E3611A-07E-S

SERVICE NOTE

E3611A - Manual DC Power Supply

The AC power module can accidentally come out of the instrument creating a shock hazard.

Situation:

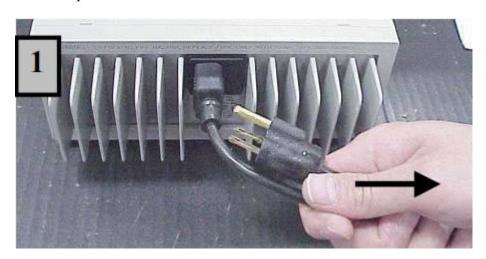
If the AC line cord is forcefully pulled in a side-to-side direction the AC module can be pulled out of the rear heat sink, exposing the conductors that carry AC line voltage.

CAUTION: TEST FOR LOOSE AC MODULE

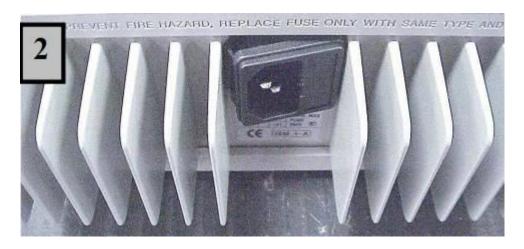
- 1. Make sure line cord is removed from outlet.
- 2. With line cord securely inserted in AC module as shown, pull forcibly (2 times) in direction of arrow.

LOOSE AC MODULE

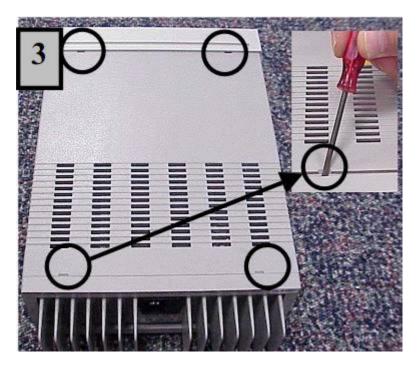
- 1. If the AC module pulls out from unit as shown it will need to be replaced.
- 2. If the AC module remains in place it does not need to be changed. Put a mark on the AC input label in the lower left hand corner with indelible ink to indicate that AC module has been checked. This label can be found below the AC module.

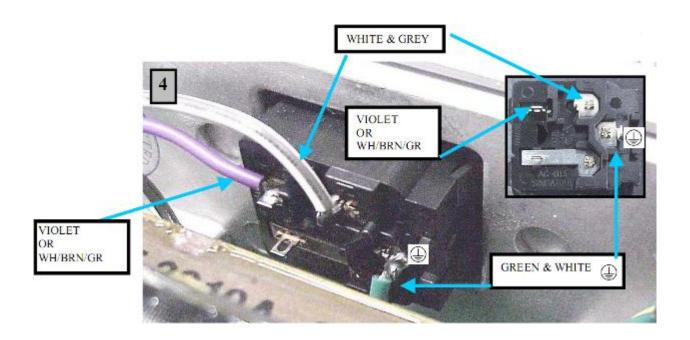
REMOVE COVER by prying rear bezel and front panel away from cover in four places as shown. Then lift cover off unit.

REPLACE MODULE with P/N 5065-6978. Before soldering perform "TEST FOR LOOSE AC MODULE" as shown in the picture above. This will confirm that the new module is secure. Solder wires and **REPLACE FUSE**.

110/120 VAC input use fuse P/N 2110-0702 (2 amp, 250 volt) 230 VAC input use fuse P/N 2110-0599 (1 amp, 250 volt)

CAUTION: WIRING MUST BE CORRECT OR HEAT SINK COULD BE AT LINE POTENTIAL.

CAUTION: MAKE SURE SAFETY GROUND IS ATTACHED TO HEAT SINK.
